CITY OF SUPERIOR, WISCONSIN
DEPARTMENT OF PUBLIC WORKS

CONTRACT NO. 3
LIFT STATION & STORAGE IMPROVEMENTS

SHEET G-7

METER MANHOLE

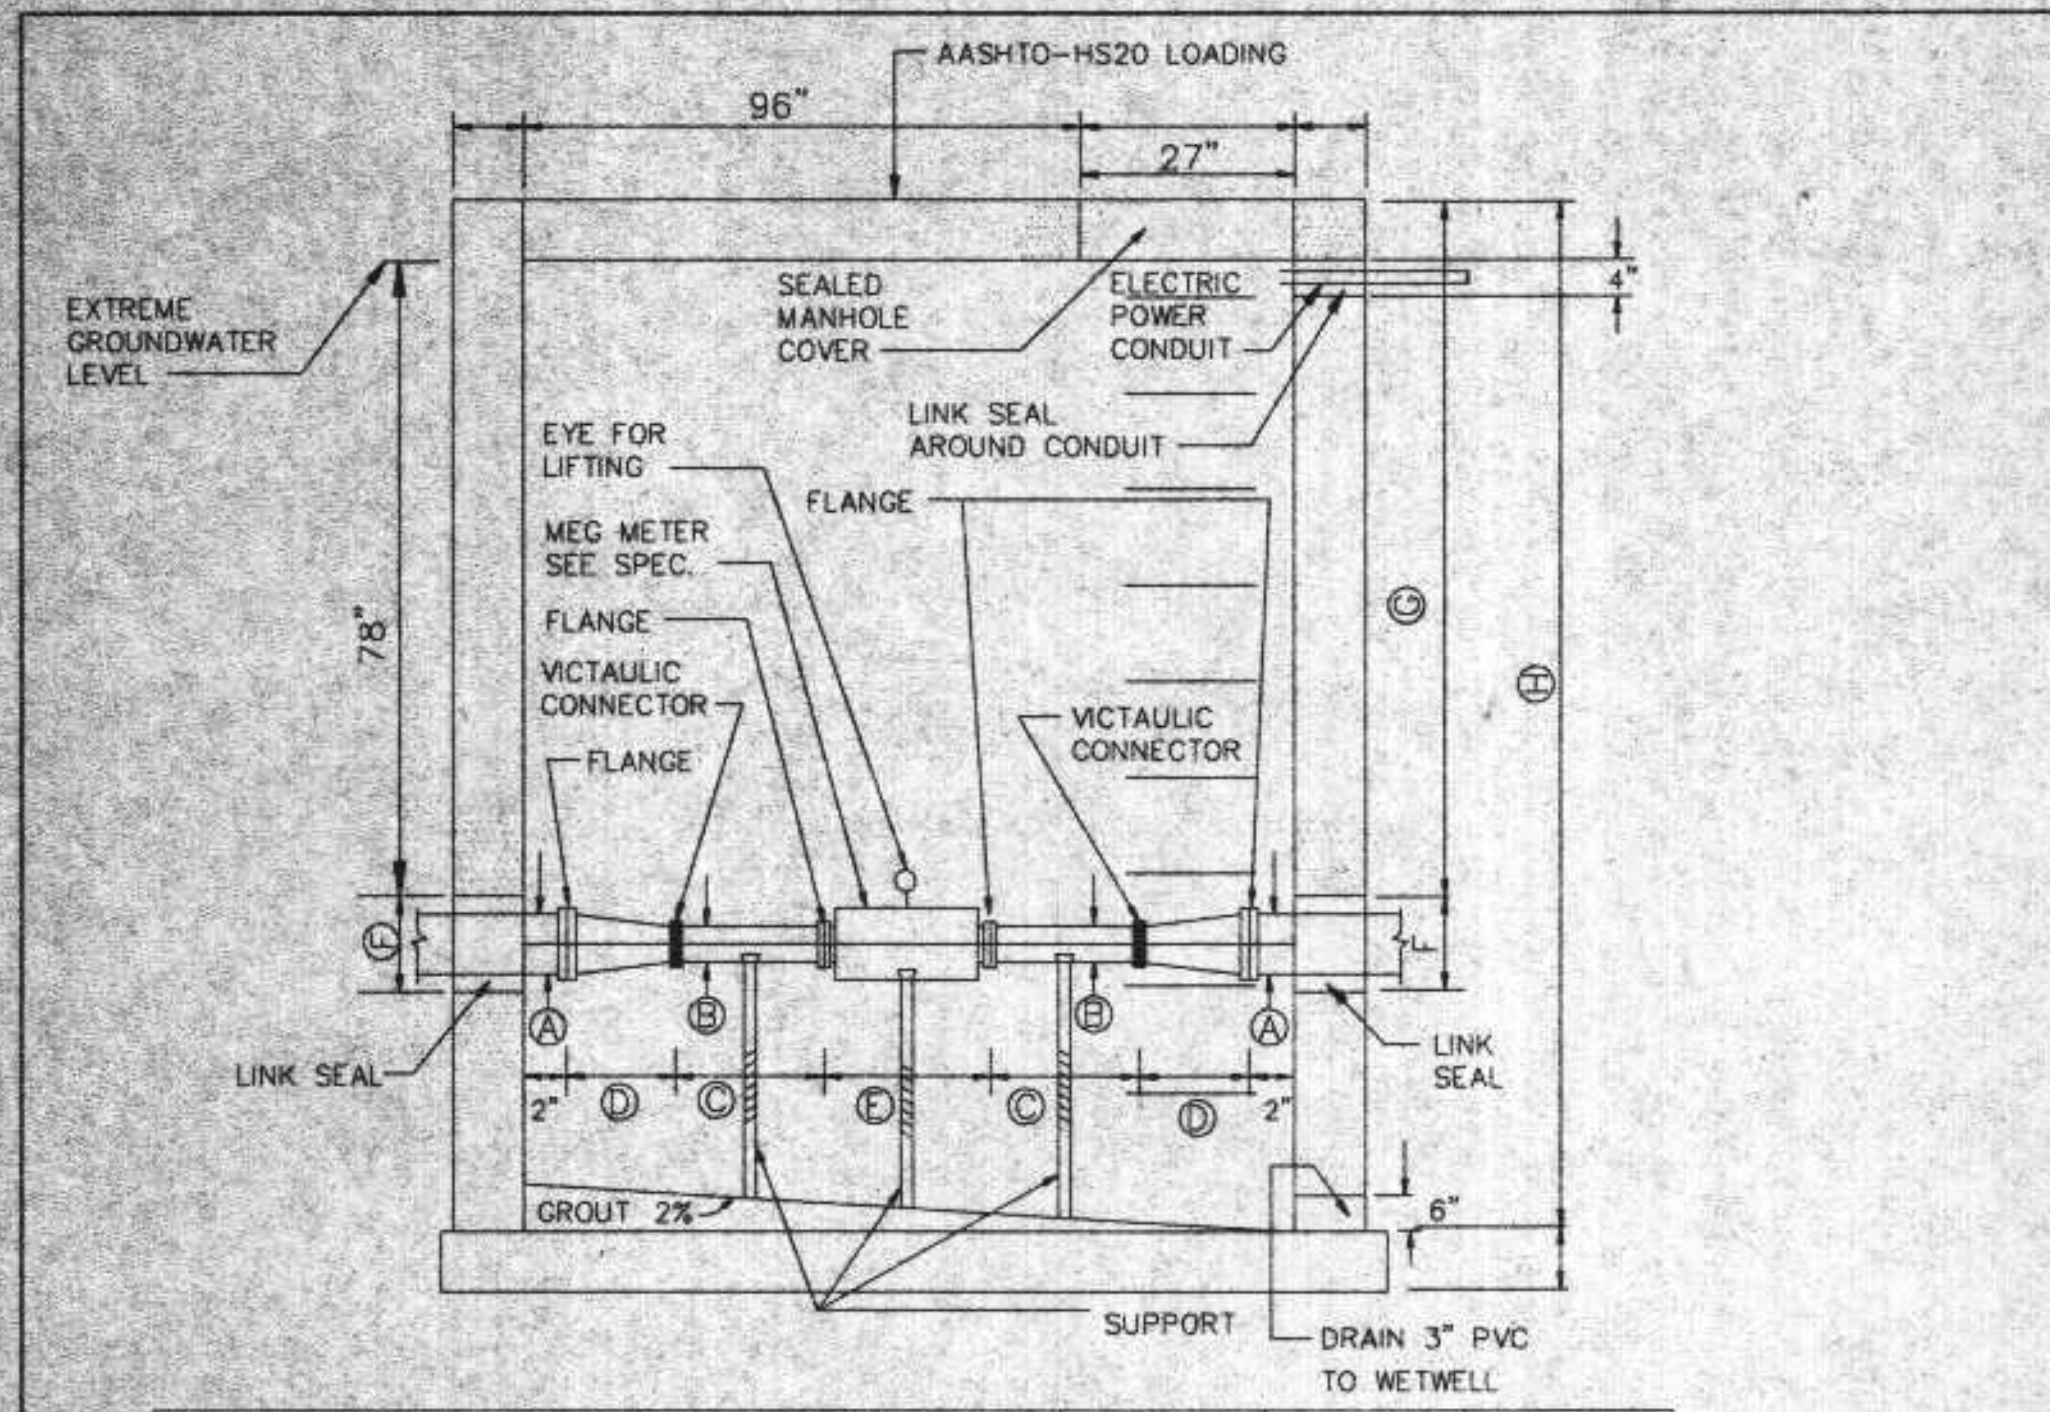
- Add following to meter manhole drawing:

LIGHT POLE

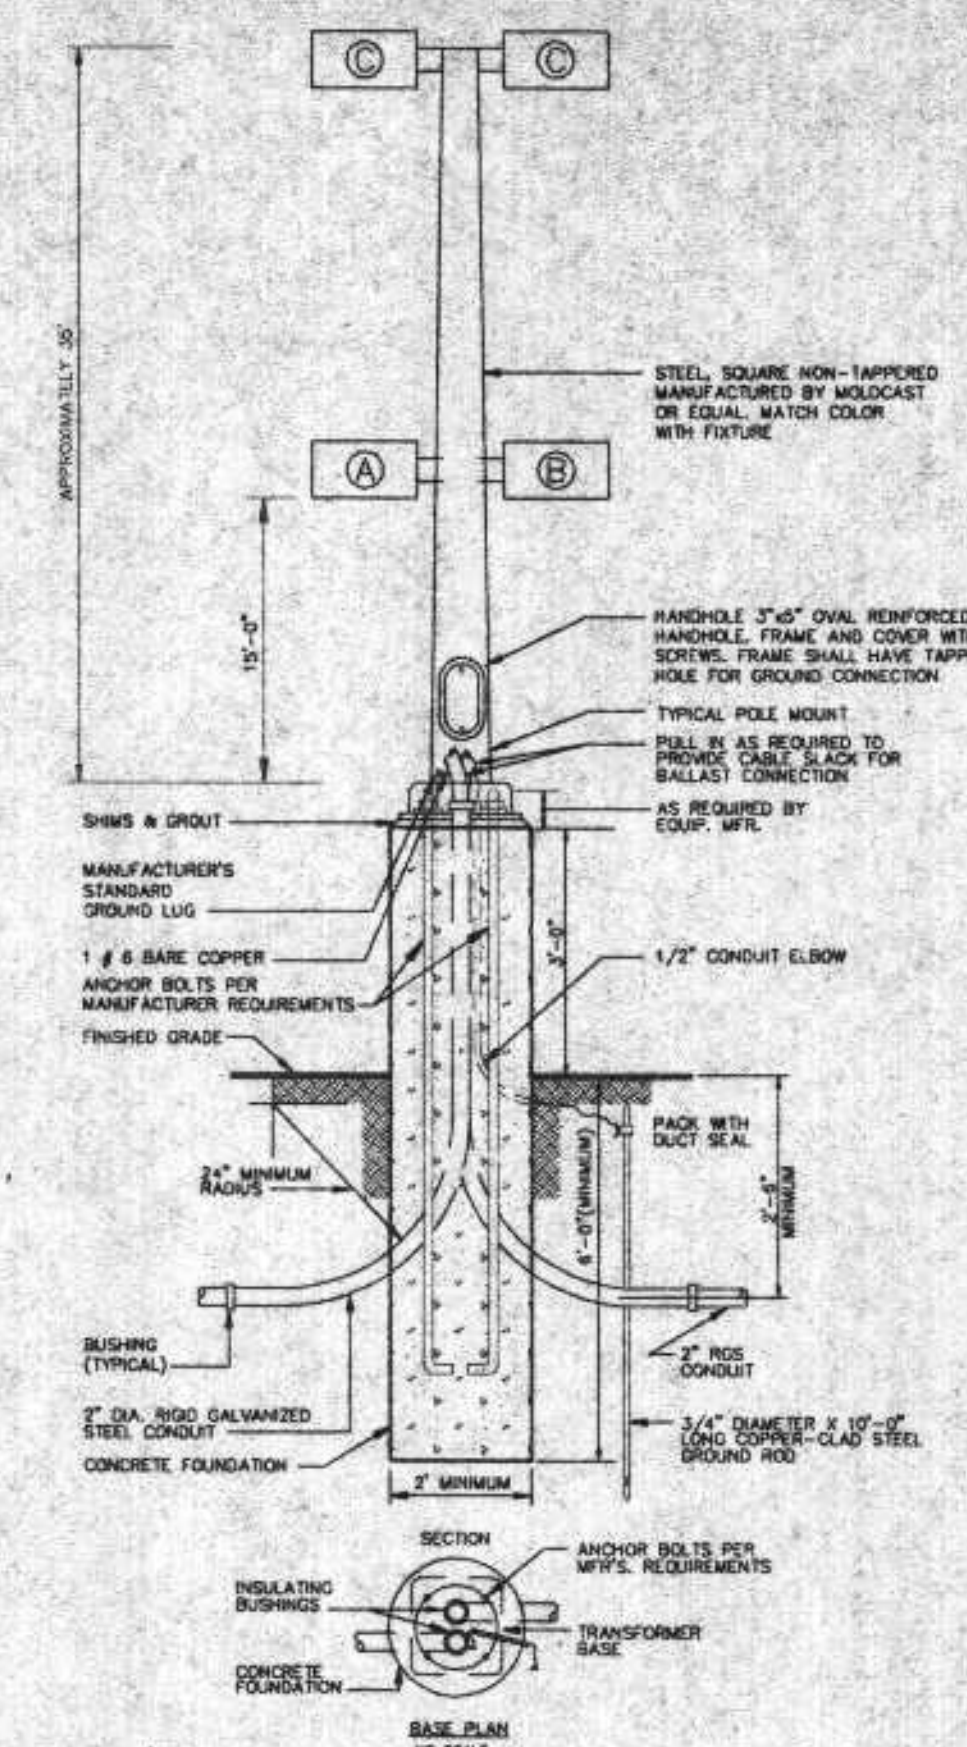
Add following to light pole drawing:

- 120 V, 20 Amp, GFCI, weatherproof duplex receptacle to be provided at base of all light poles. Receptacles to be switched at control panel.
- Switches to control yard lighting to be housed in control panel.

ULTRASONIC LEVEL METER

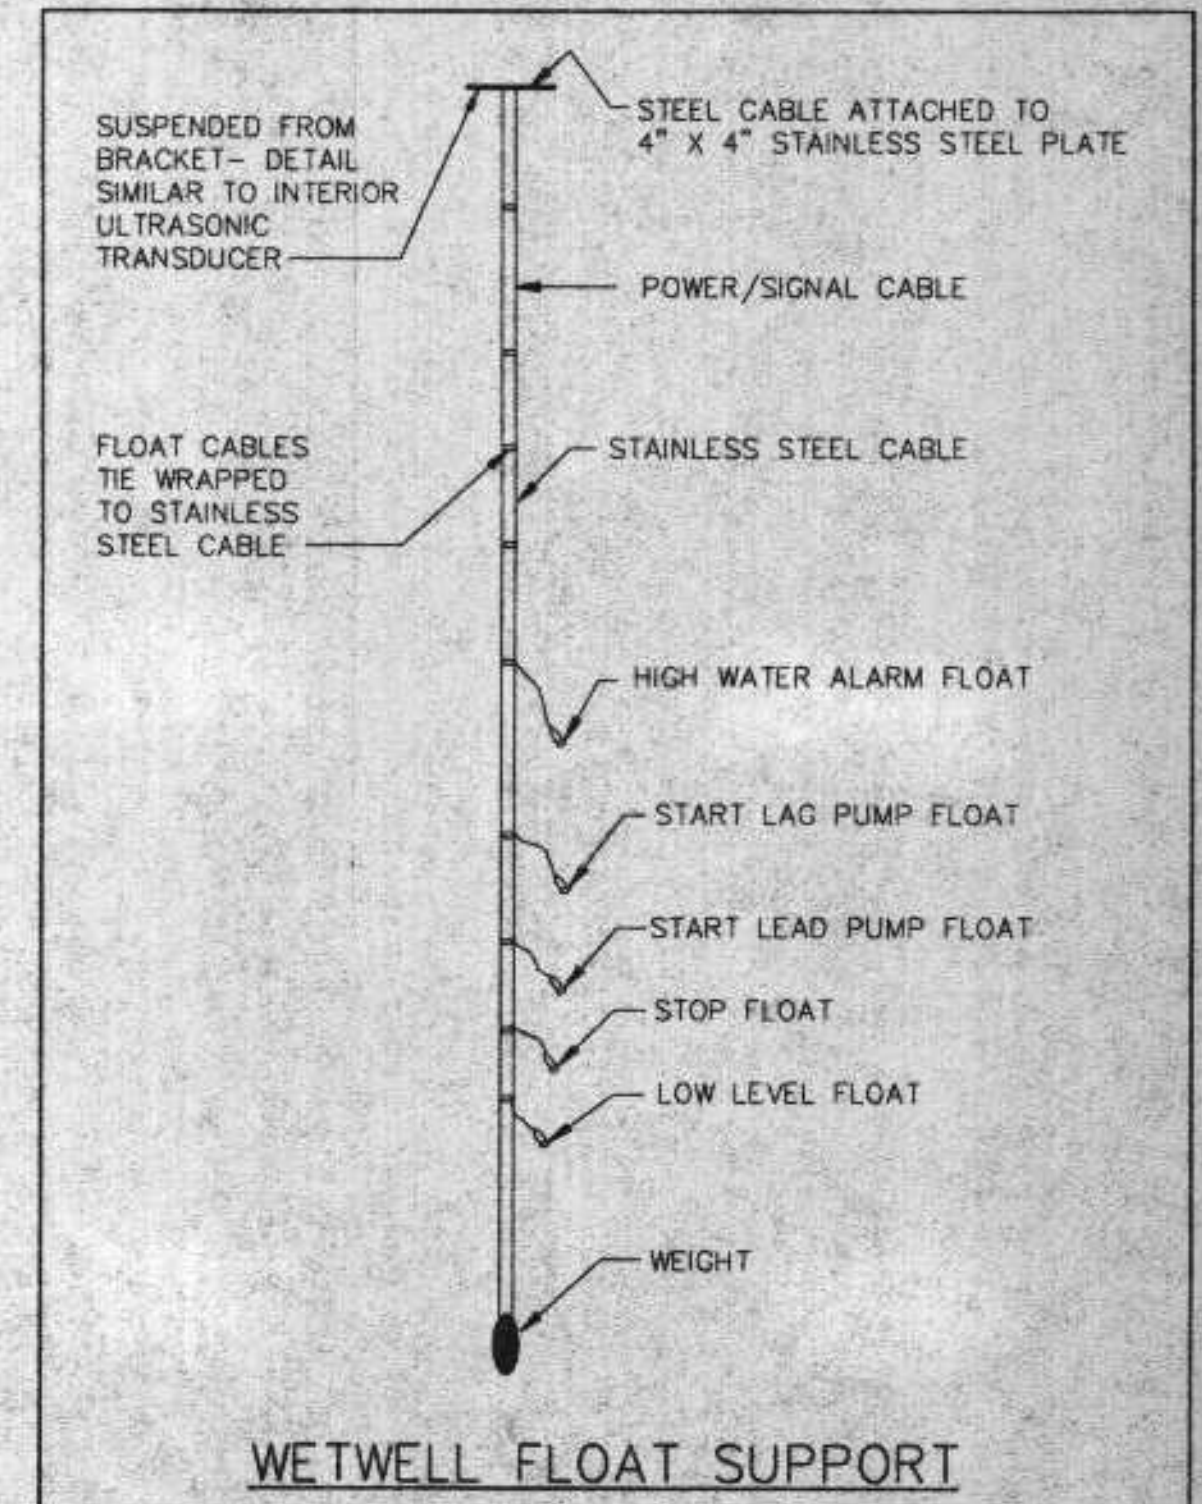
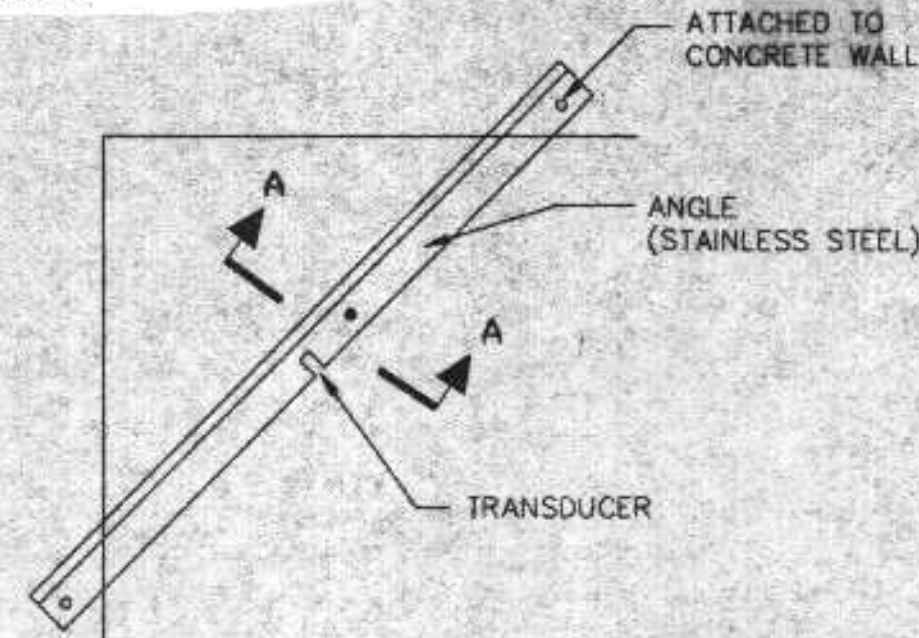
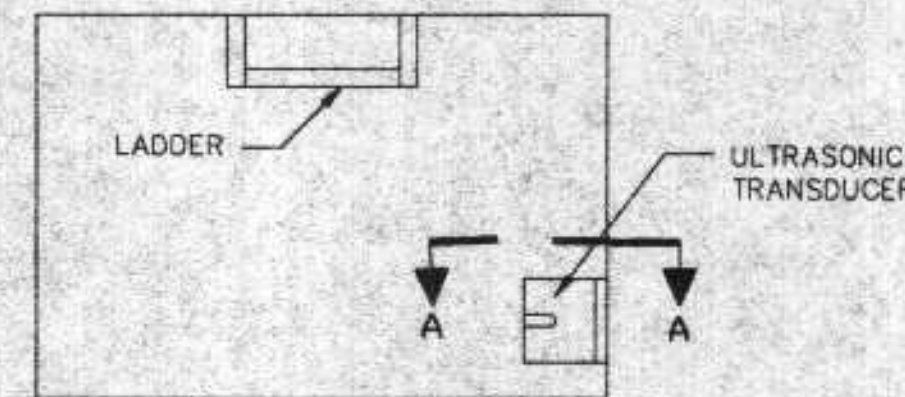
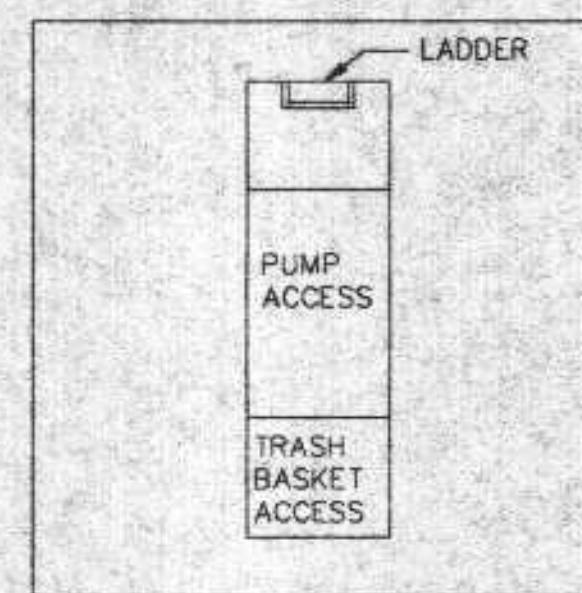
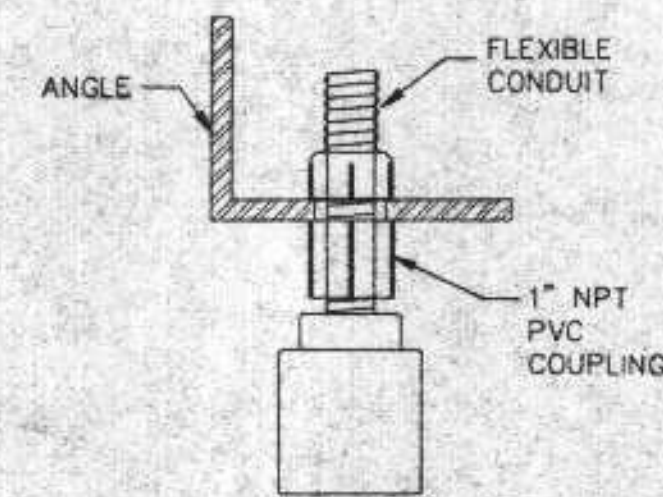
Sheet G-7:

- Remove davit crane drawing and information (see revised crane in Item 6 of Specifications above).
- Rename Ultrasonic Level Meter Drawing as Level Meters and modify Section A-A with the following:

Ultrasonic Level Meter Transducer Bracket/Assembly Notes:

- All hardware and brackets to be stainless steel.
- 1/4" lip to be provided on bracket.

Float Tree Bracket/Assembly Notes:

- Float tree cable to be stainless steel and attached to 1/4" stainless steel plate for placement on bracket.
- All hardware and brackets to be stainless steel.
- 1/4" lip to be provided on bracket.
- Stainless steel handle for lifting of float system to be provided.
